January 24, 1985
PY-CEI/NRR-0173L

Perry Nuclear Power Plant
Docket Nos. 50-440; 50-441
IDI Inspection 84-29 Response

Enclosed is The Cleveland Electric Illuminating Company's response to the results and conclusions of the Integrated Design Inspection of the Perry Nuclear Power Plant. The inspection results are contained in NRC Inspection Report 50-440/84-29, transmitted by your letter of December 12, 1984. The response describes CEI's reviews, evaluations, and corrective actions conducted during and after the inspection. As noted in our response, CEI executive management has closely followed the Integrated Design Inspection and established our response as the top priority in the current PNPP design effort. The format of our response is as follows:

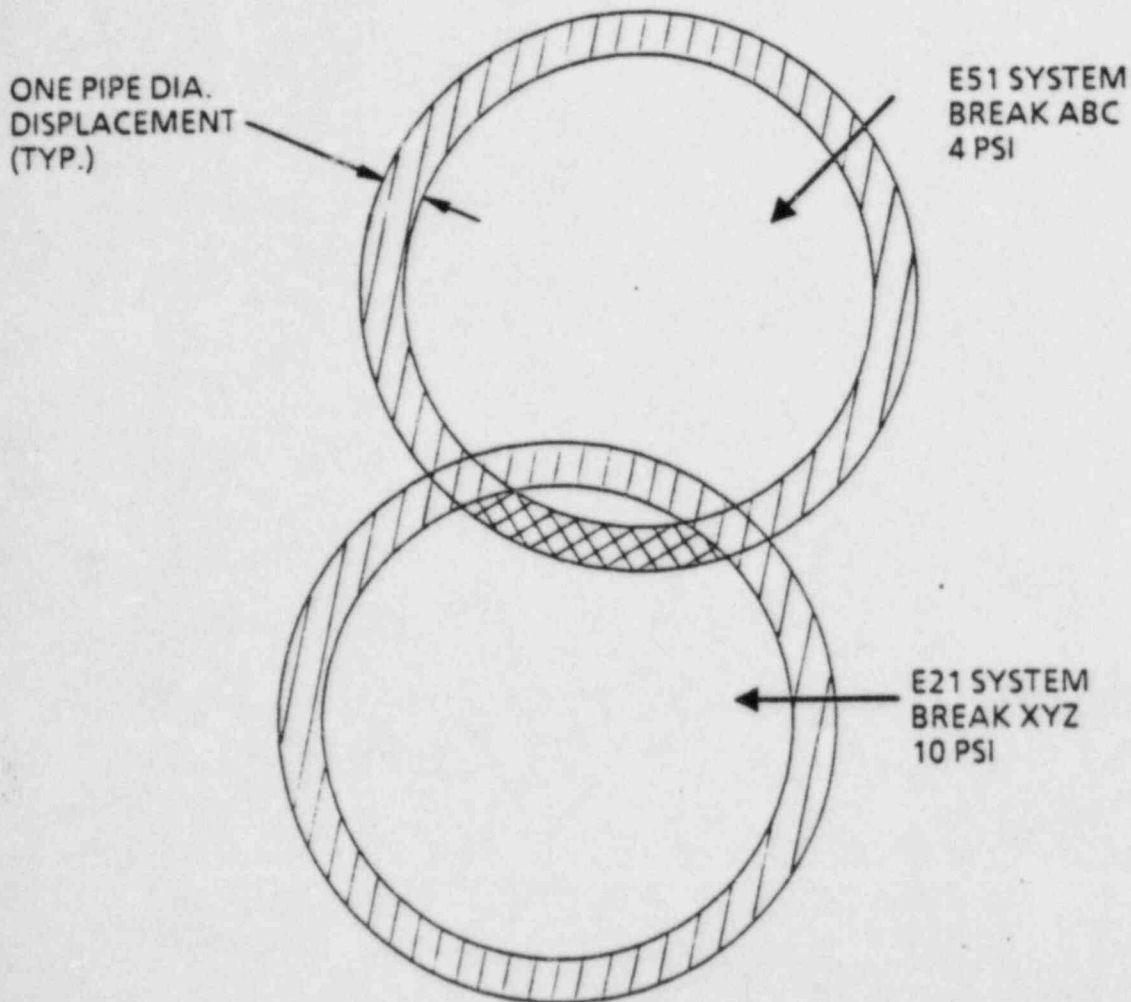
This item states that the method used in the pipe break and jet displacement study (Jet Study) to determine increases in jet impingement envelopes due to pipe displacements potentially excluded some targets which should have been included.

We concur with the IDI Report that the potential exists for missed targets in the discontinued band (See Figure 1) due to the methodology used. The impact, however, of not investigating for additional targets in the discontinued band is considered insignificant based upon the following:

1. Approximately 50% of the jet impingement envelopes do not have any overlap, or the overlap is from breaks within the same piping system, so the higher pressure jet will be the limiting design case.
2. For the remainder of the jet envelopes, the actual physical area of the discontinued band in relation to the full jet envelope is typically very small. Figure 1 is representative of this relationship. As a result, there is a low probability of a safety-related component being located totally within this excluded zone. Thus, structures, systems, and components are still appropriately protected against any discharging fluid from a ruptured pipe, as required by 10 CFR, Part 50, Appendix A.
